This Service Information bulletin supersedes SI B65 13 14 **dated July 2014.**

Service Action: i3 Business Navigation – Retrofit

I01 (i3 REx)

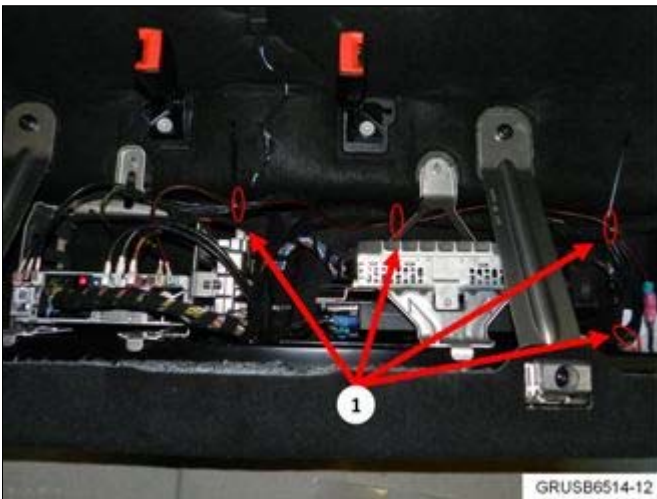
10. Identify the pink GPS antenna connector that was removed from the old TCB (1). Connect the male end of the adapter cable (2) to this pink connector. The adapter cable (P/N 61 12 2 361 716) will extend the antenna cable to its new terminal end at the head unit.

11. Route the extension antenna cable along the existing wire harness, under the support bracket, to the head unit as shown.

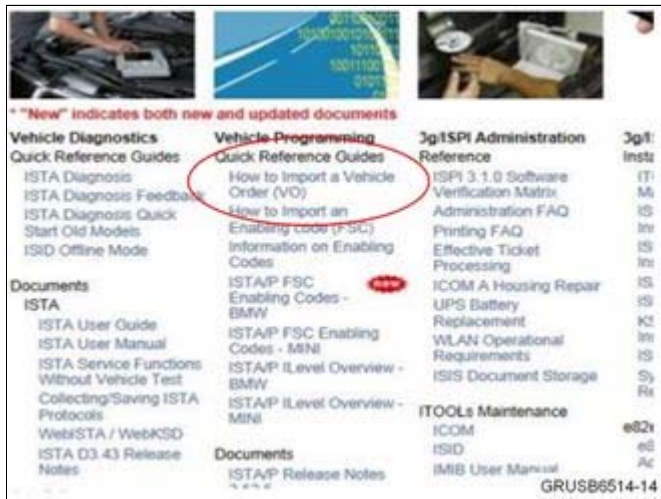
12. Connect the female end of the extension cable to the outermost blue GPS connection on the head unit (1).

13. Secure the adapter cable to the existing wire harness using four wire ties in the displayed locations (1).
